Final Plat
SUBDIVISION REPORT

SUBDIVISION COMMITTEE
METROPOLITAN AREA
PLANNING COMMISSION

S/D No.: 86-43 Name: THE DUGAN CENTRE

Re: S/D 86-43 - Final Plat of The Dugan Centre.

FINAL PLAT

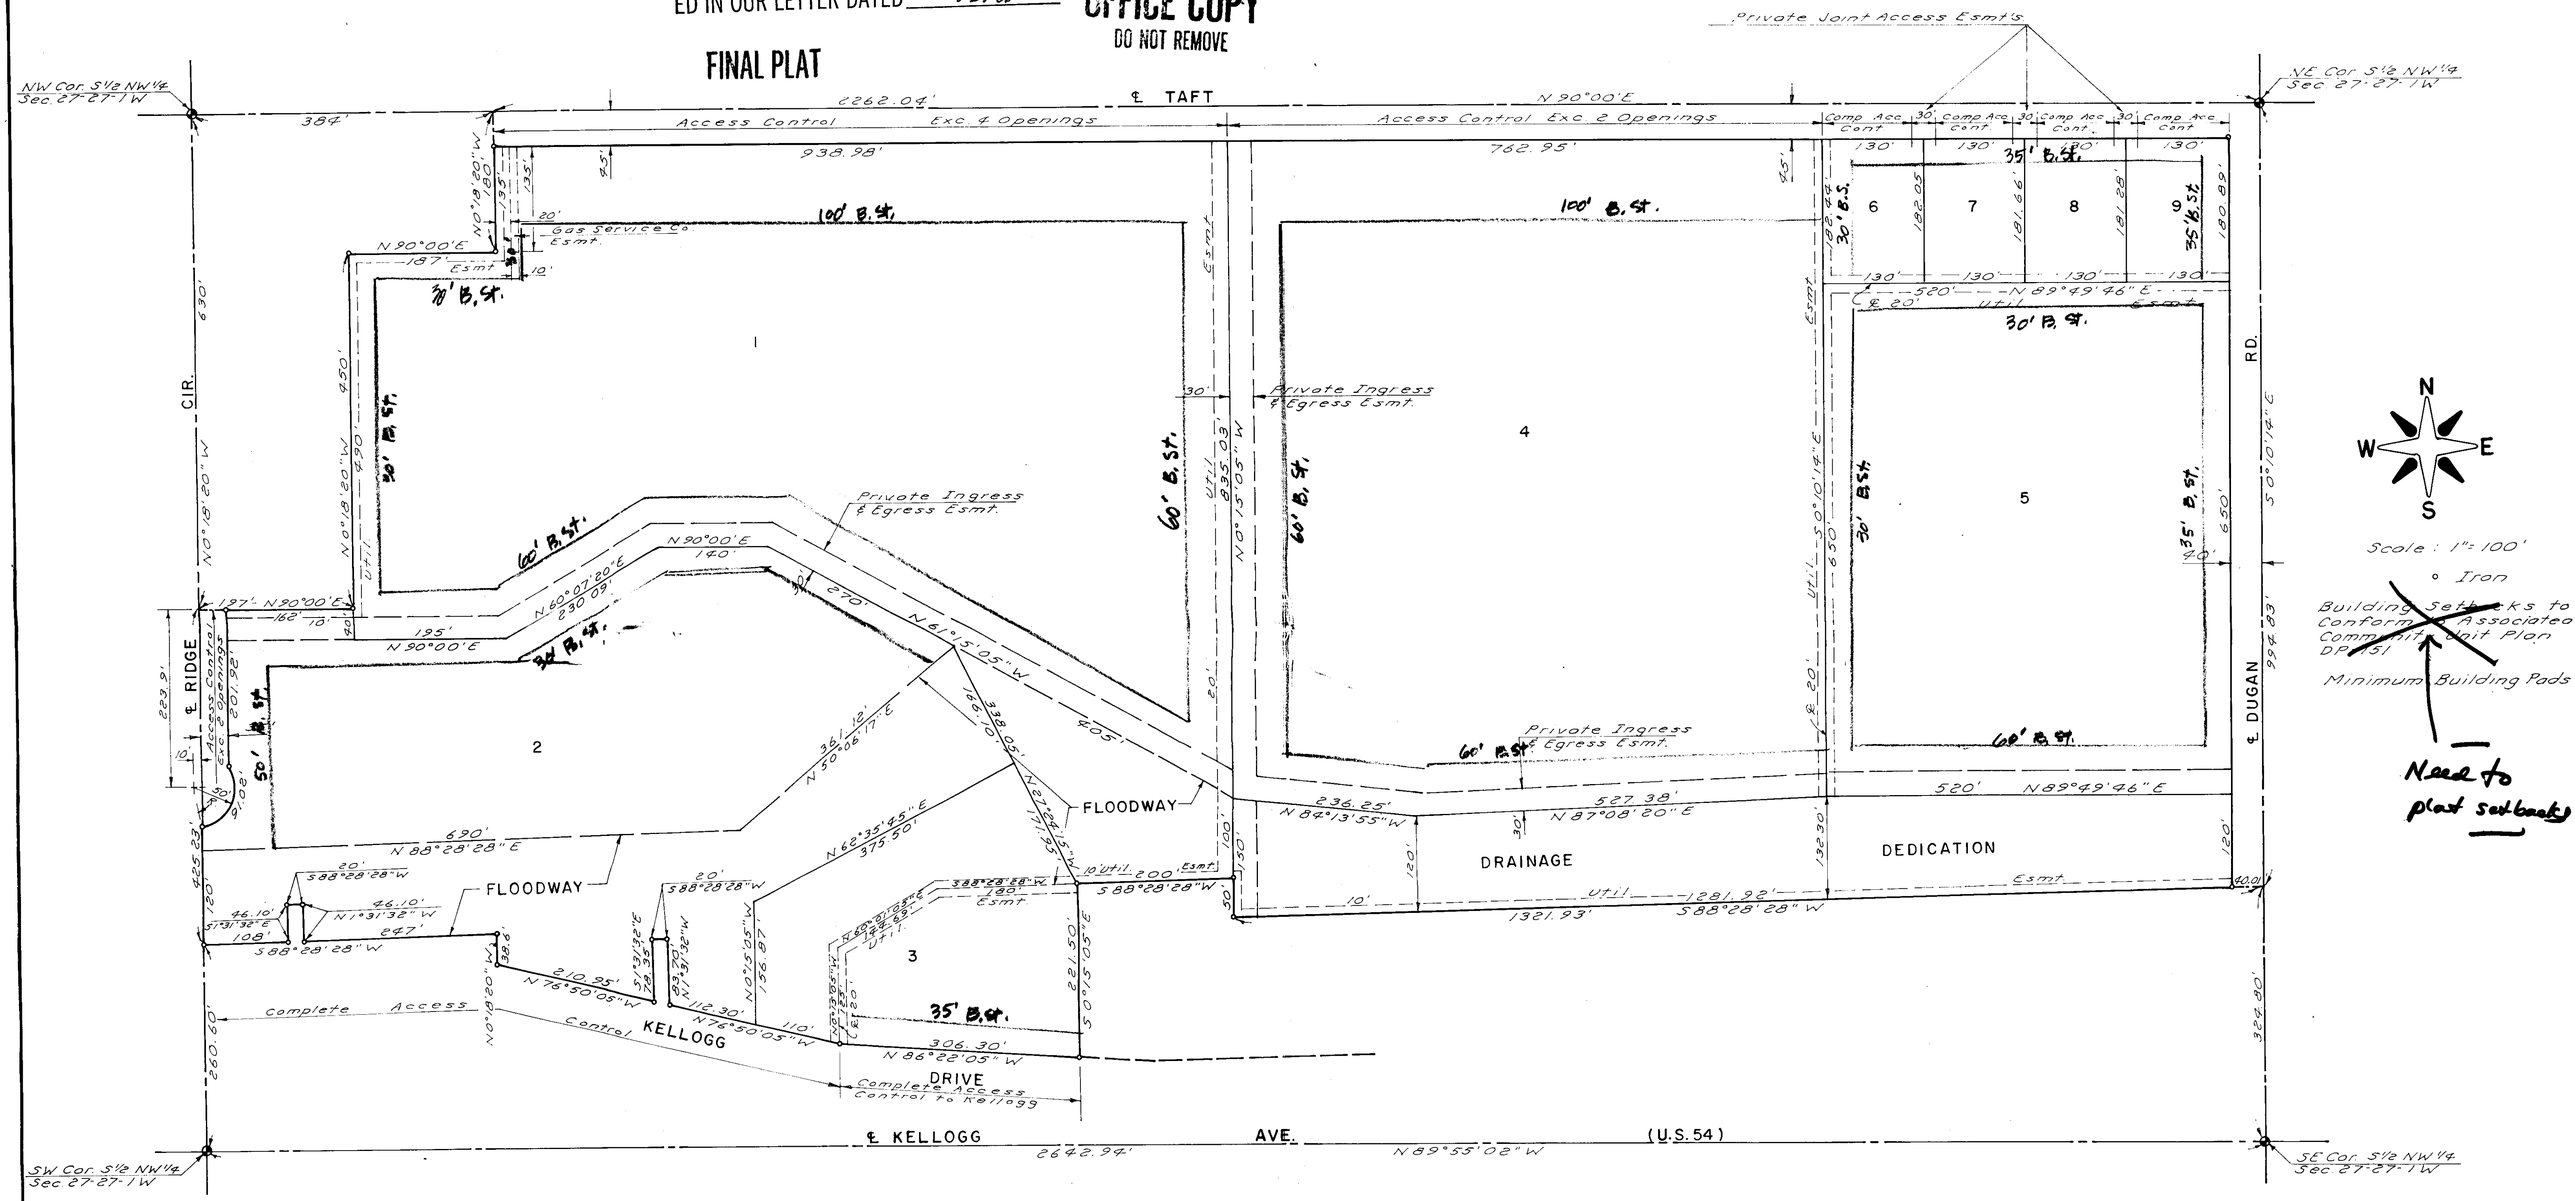
N. The final plat tracing shall indicate the platting of the building setbacks required by the Community Unit Plan.

O. The final plat tracing shall indicate the platting of required minimum building pad elevations. They shall be noted on the face of the plat as well as in the plattor's text.

P. Regarding the three joint access easements proposed to provide access from Lots 6, 7, 8 and 9 to Taft, it is necessary to establish the joint access easements by separate instrument. This is necessary in order to provide recording information on the face of the plat which will refer any future owner of the subject lots to the document outlining and setting forth the particulars of the joint access easements. Prior to recording the joint access easement, a draft shall be submitted to the Planning Department for review and approval. The instrument must clearly state the prupose of the easement as well as which properties benefit from the easement. Initial construction responsibilities and future maintenance of the driveway within the easement and the approaches to Taft should also be addressed by the text of the instrument.

Q. Regarding the 30-foot wide east/west and north/south access easements depicted on the plat, it is necessary to establish these access easements by separate instrument with appropriate recording information indicated on the final plat tracing. Prior to recording the joint access easement, a draft shall be submitted to the Planning Department for review and approval. The instrument must clearly state the purpose of the easement as well as which

properties benefit from the easement. Initial construction responsibilities and future maintenance of the driveway within the easement should also be addressed by the text of the instrument.

No need to plat.
